APICAL INDUSTRIES, INC.  
dba DART AEROSPACE

ENGINEERING CHANGE NOTICE NO.

07035

DWG TITLE: SPRING CAP

## SHEET 1, FRONT VIEW AND SECTION E-E WAS:

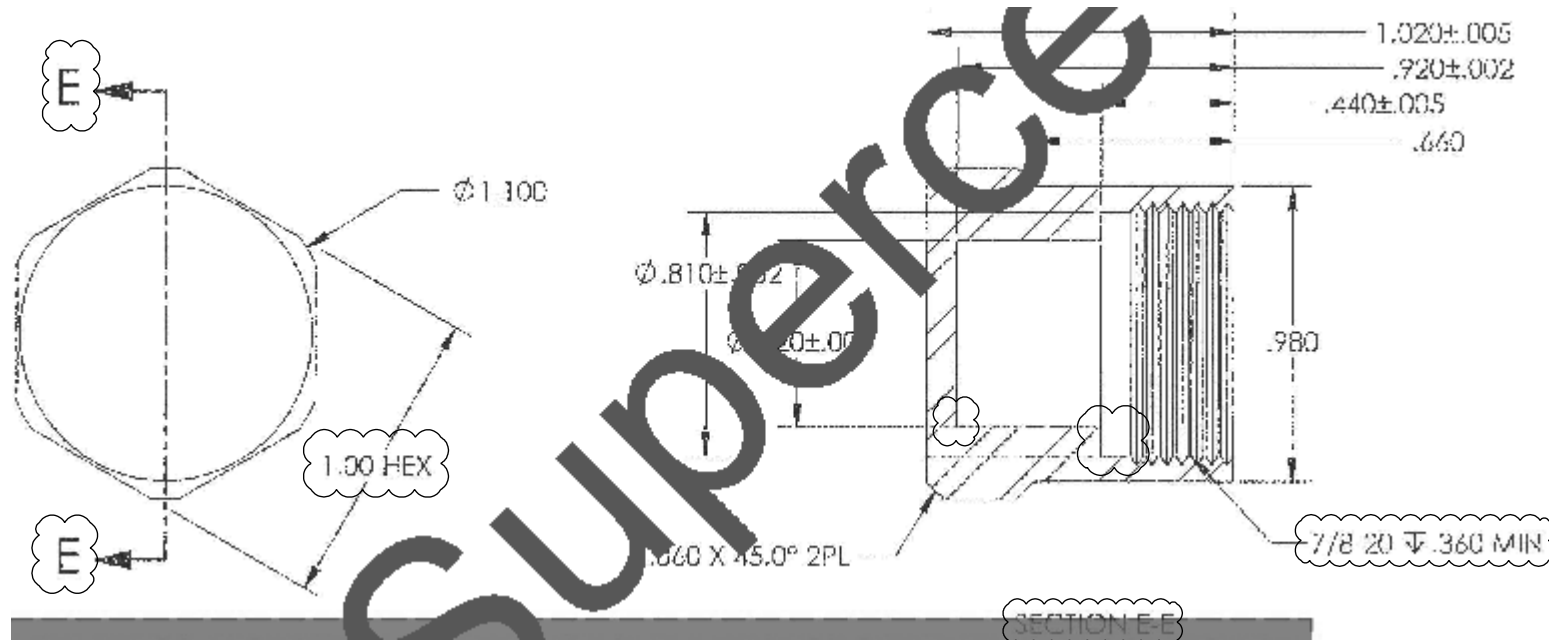
**REASON:** INCORPORATED UNINCORPORATED ECN 03299. REVISED TEMPLATE AND VIEWS FOR CLARITY. REVISED NOTES.  
REVISED HEX HEAD TOLERANCE. ADDED SURFACE ROUGHNESS AND RADII (FOR MACHINING) AS REQUIRED.
